BID: FR-24 ISLANDTON FIRE STATION 15 EXPANSION

ADDENDUM 1 DATED: MARCH 18, 2020

The following questions have been submitted for clarification:

DOOR TYPE ELEVATIONS

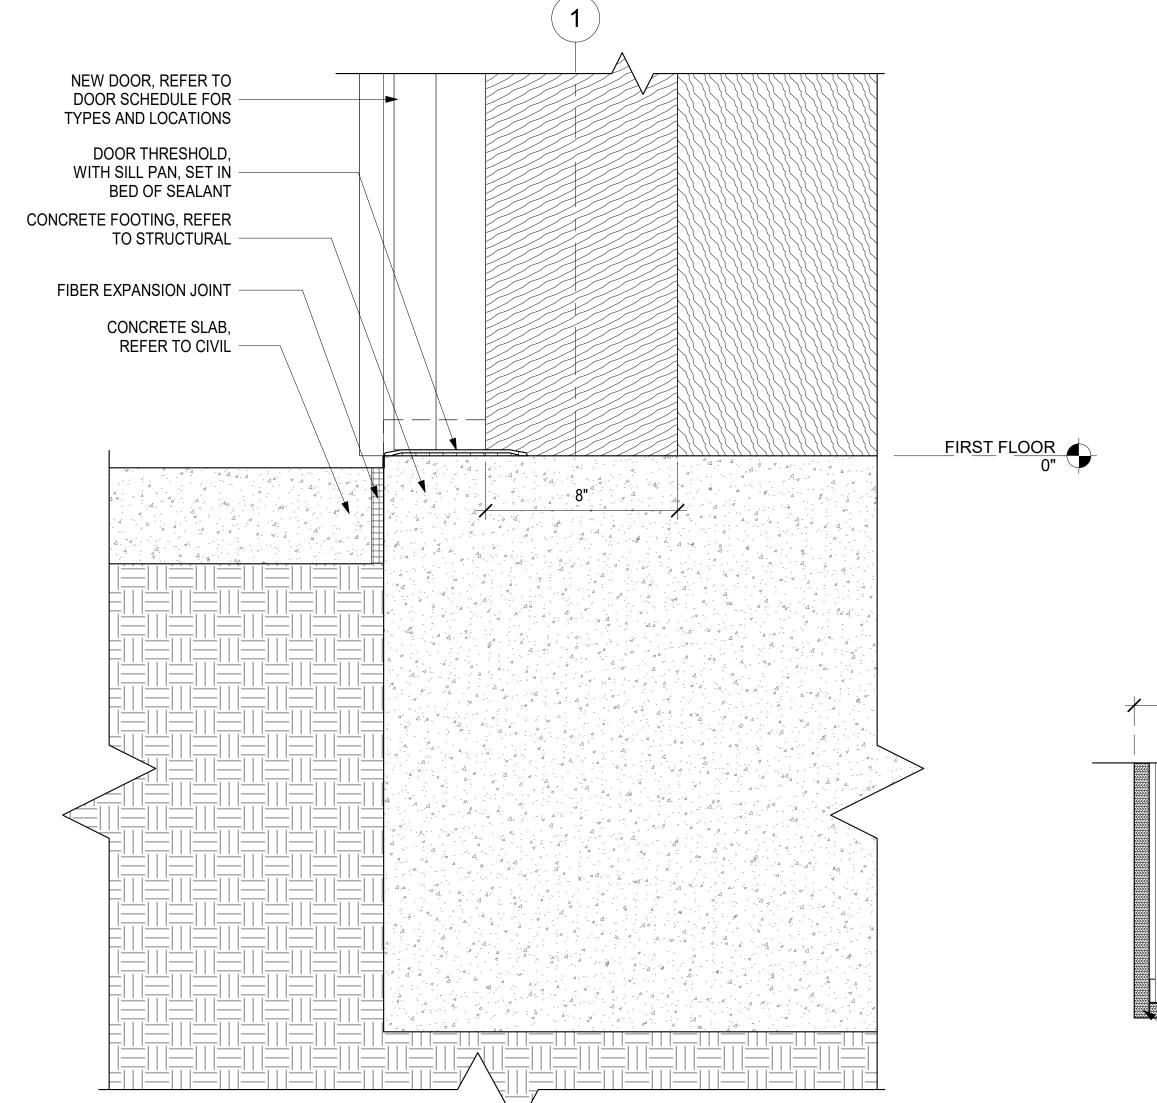
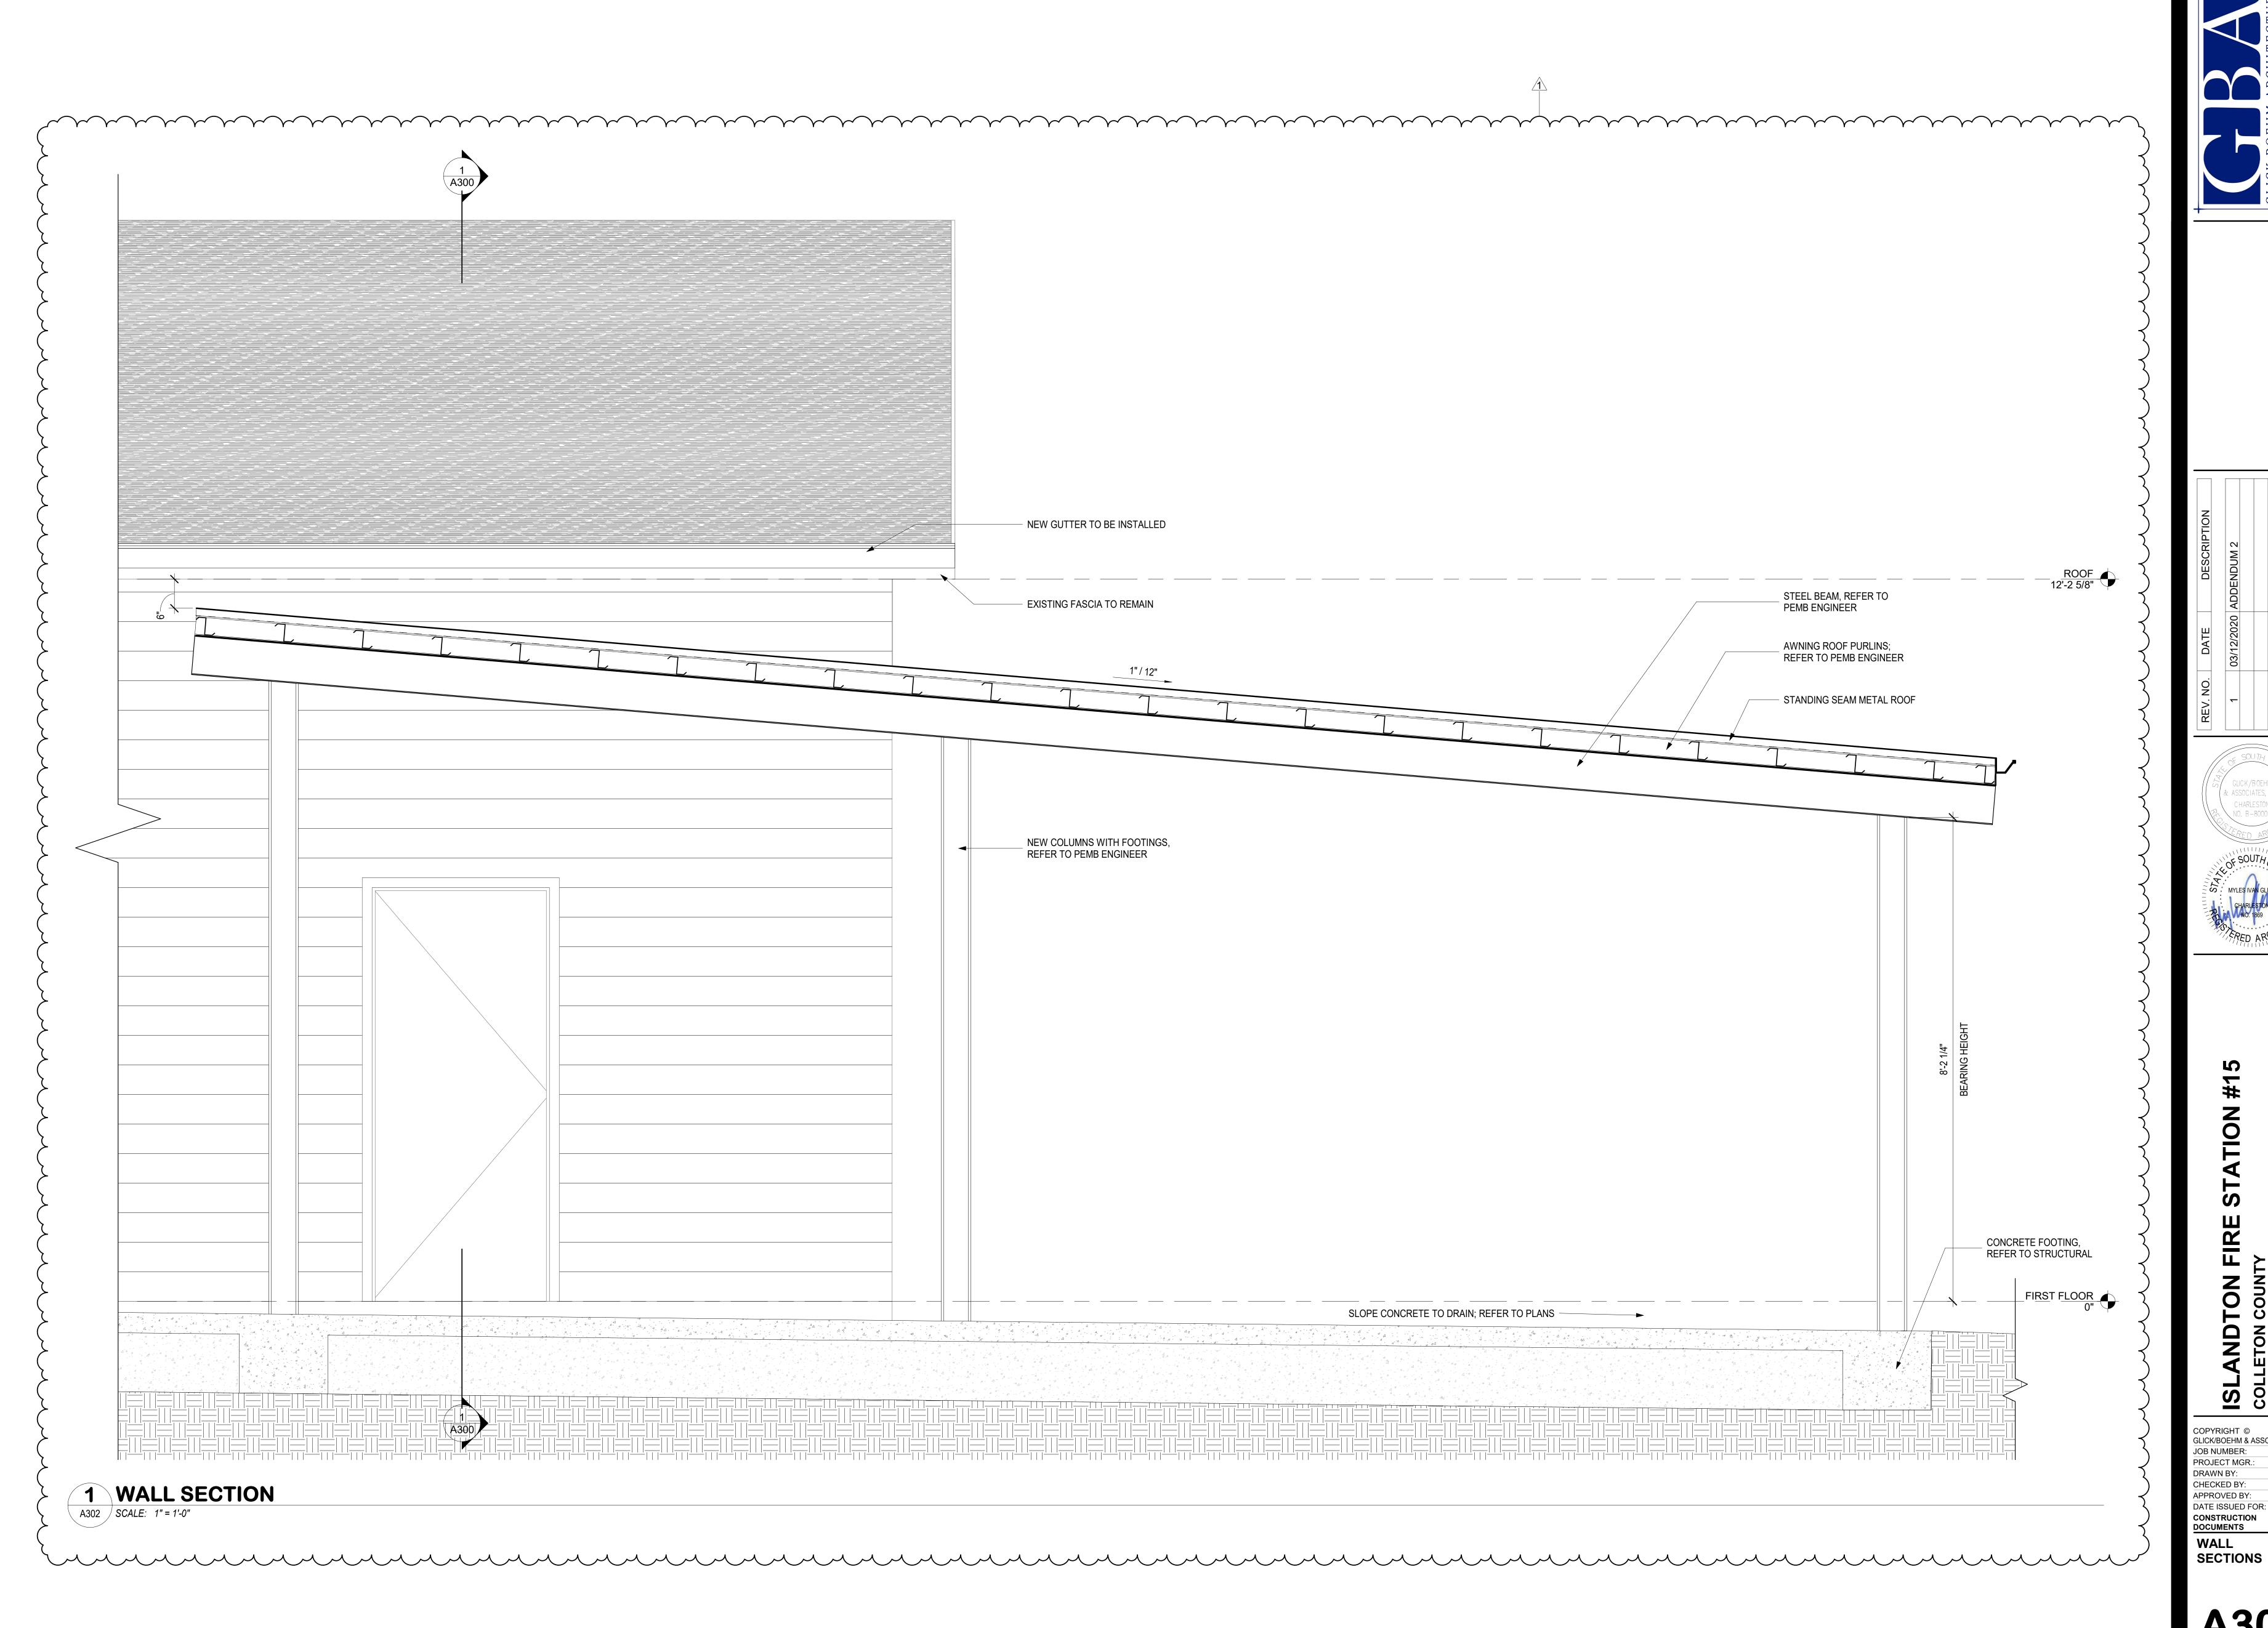
- 5. The door elevation of the OH Door shown on A600 indicates (3) lights, however, the building elevations on A200 do not. Which is correct? Answer: Provide windows in garage door per revised A200 & A600 attached. The garage door shall be Amarr-2432 2" Polystyrene Insulated Section Door. See attached door provider and installer.

- 7. The door & frame schedule on shows Door 7 is a 03-type door with HM finish, however, the Door Schedule Notes indicate on Note 3 that 03 Door is to be solid core wood. Which is correct?

Answer: Provide a hollow metal door.
- 8. Please provide more detail for the storage room.
 - a. Wall finish? Answer: Painted P.T. Plywood
 - b. Base? Answer: 1x6 P.T. wood base, paint
 - c. Ceiling height? Answer: 8'-0"
 - d. Walls to be constructed out of wood? <u>Answer:</u> 6" metal studs at 16" o.c. per wall type, W3 noted on drawings.
 - e. Insulated? Answer: Yes, per wall type W3 noted on drawings.
 - f. The ceiling is PT plywood. Do you want it painted? Answer: Yes.
- Confirm you want the apparatus bay exposed ceiling and walls painted. <u>Answer:</u> Paint wood base
 & plywood walls. Exposed steel shall be factory primed dark gray.
- 10. Do you want the Hose Dryer Tower painted? <u>Answer:</u> No.

3 TYPE 03 DOOR TO BE PAINTED, HOLLOW METAL DOOR
